6-H-20-HZ
APPLICATION FOR CERTIFICATE OF APPROPRIATENESS

428 E. Scott Ave. 37917
 Old North Knoxville H-1

Staff Report - Certificate of Appropriateness Application

File Number: 6-H-20-HZ

Proposed Front Elevation

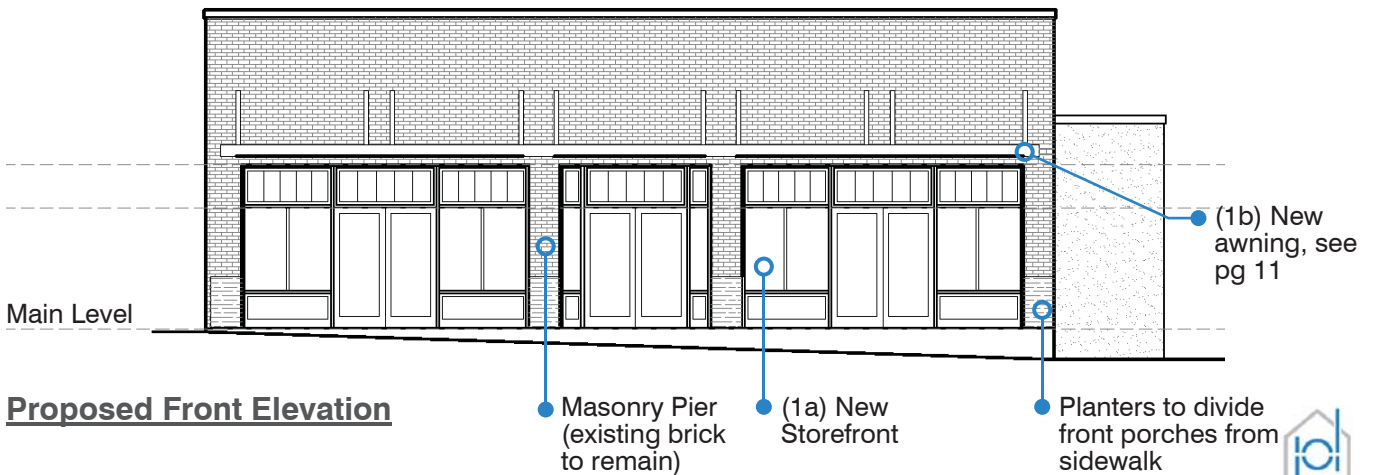
2. Rehabilitation of the storefront draws from a 1930s photograph and the façade of a comparable structure built in Fort Sanders in 1926. The applicant proposes to install two storefront systems flanking a full-light double door. Storefront systems will feature bulkheads and four-light transom windows. The storefront window system exhibit proportions and a design appropriate for an early twentieth-century commercial building. Design of the façade restoration is appropriate.

3. The applicant has presented options of both metal and wood storefront systems for the façade, requesting that staff be granted the final approval of material. The neighborhood has expressed a preference for wood storefront systems. In staff's opinion, wood, metal, or aluminum-clad wood would be appropriate, as long as the muntin profiles, trim, and window sizes reflect what's shown in the application.

4. The flat metal awning is simple in design and comparable in size, design, and materials to awnings approved on historic commercial buildings in Knoxville. The awning is appropriate for the size of the façade, extending evenly across the storefront systems and doors. The design is not overly elaborate, does not create a false sense of history, and could be removed without detriment to the historic façade.

- 1) Specifics on balcony material and design be submitted to staff for final approval;
- 2) Pending further review alongside building codes, design of east elevation be submitted for review by staff; staff retains right to recommend east elevation design return to the Commission in the event of major changes in window placement and size;
- 3) Material specifications on façade storefront systems, double-hung windows, and side elevation storefront systems be submitted to staff for approval.

Existing and Proposed - West Elevation (turn page 90°)

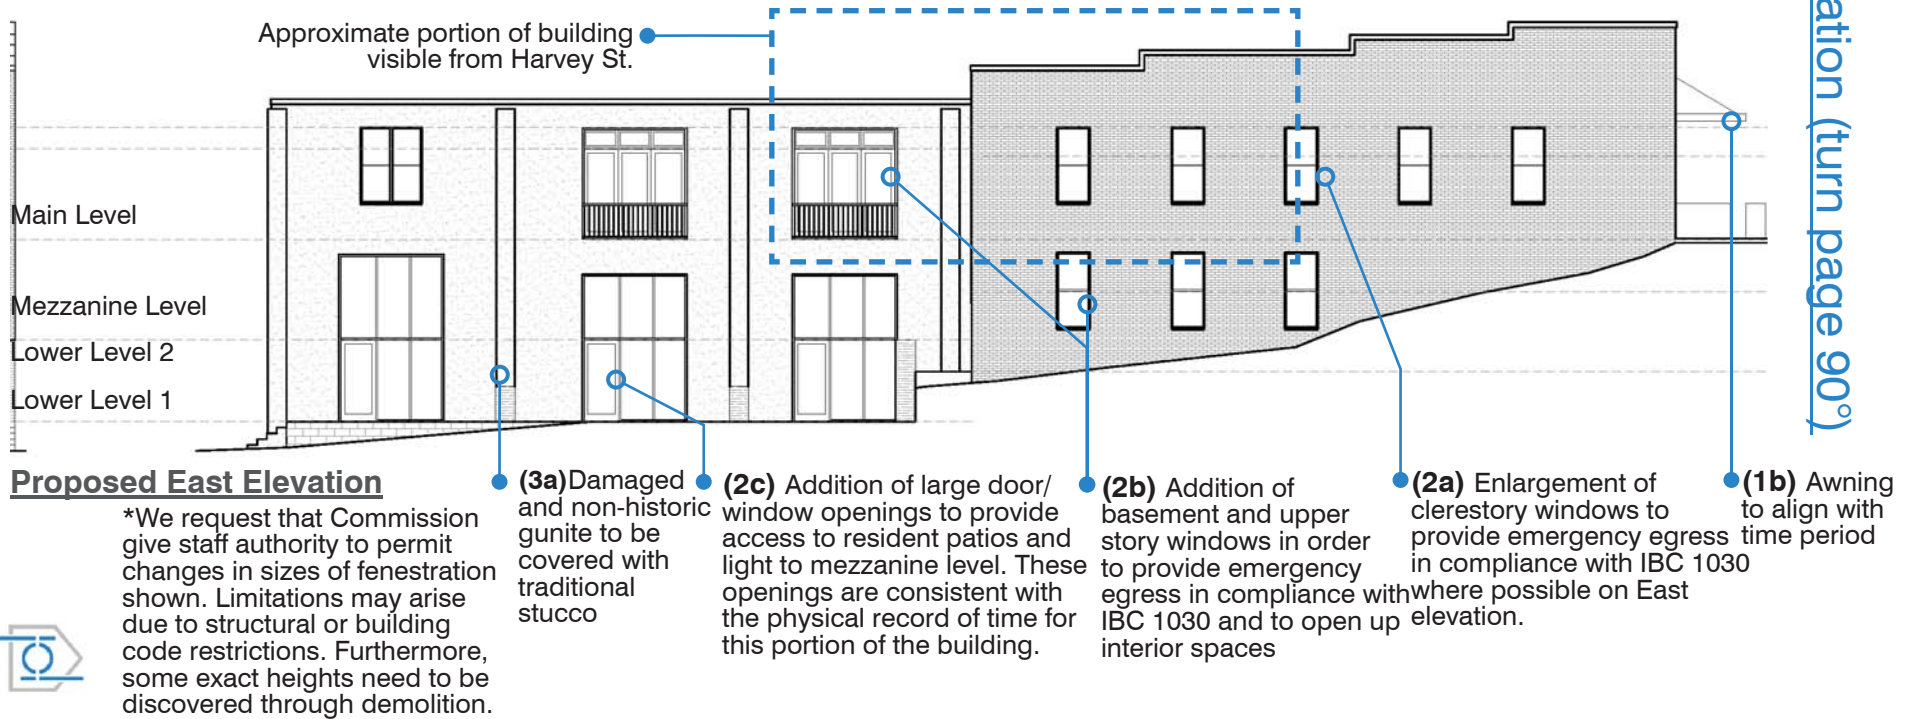
6. The proposed one-over-one, double-hung sash windows on the west elevation are appropriate for the c.1927 section. The windows will be minimally visible from E. Scott Ave. On the warehouse section, enlarging the metal industrial windows to be one-over-one, double-hung sash for egress is appropriate, and will visually tie the rear portion to the historic structure. The neighborhood has expressed a preference for wood windows.

Proposed Elevations - East Elevation (turn page 90°)

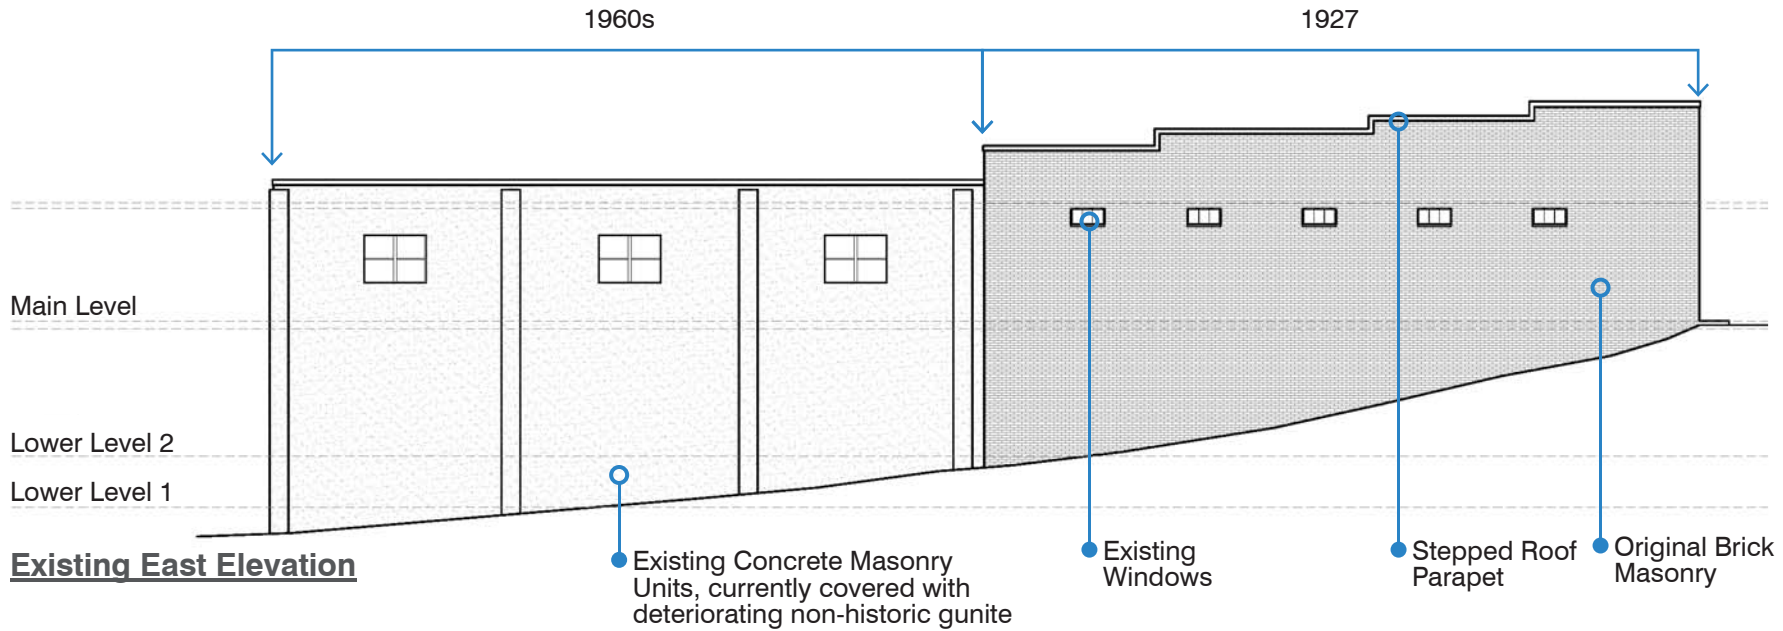
7. One-over-one, double-hung sash windows are also proposed for the c.1927 section, east elevation. Applicant notes that these windows may not be ultimately permissible due to building code restrictions and this elevation may need to be re-designed.

Existing and Proposed - Rear Elevation

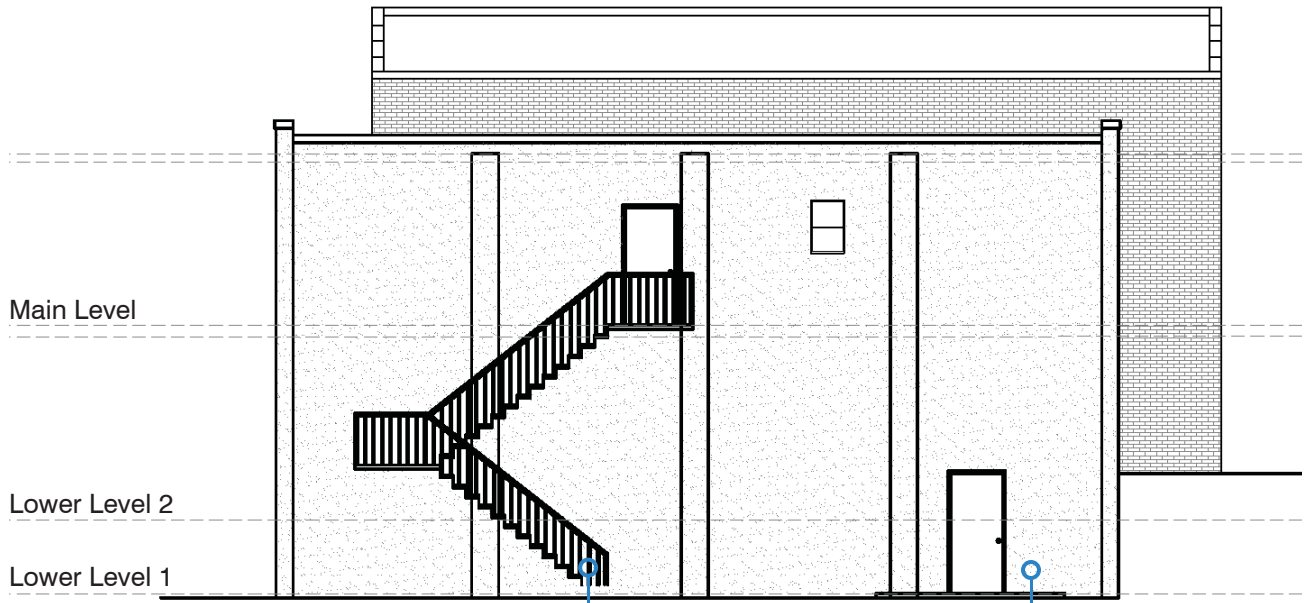
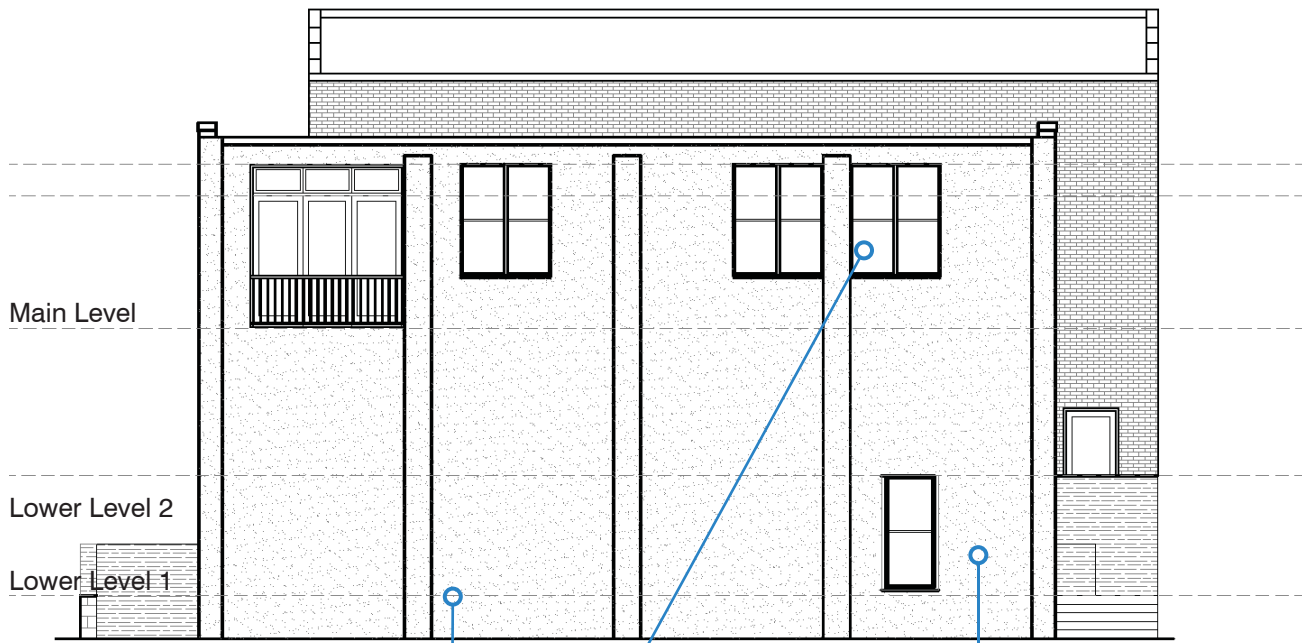
9. Rear elevation work, including the addition of double-hung sash windows, removal of metal staircase, and removal of door, is appropriate.

10. On the c.1960s section, removal of the deteriorated gunite material and covering the concrete masonry units with stucco is appropriate.
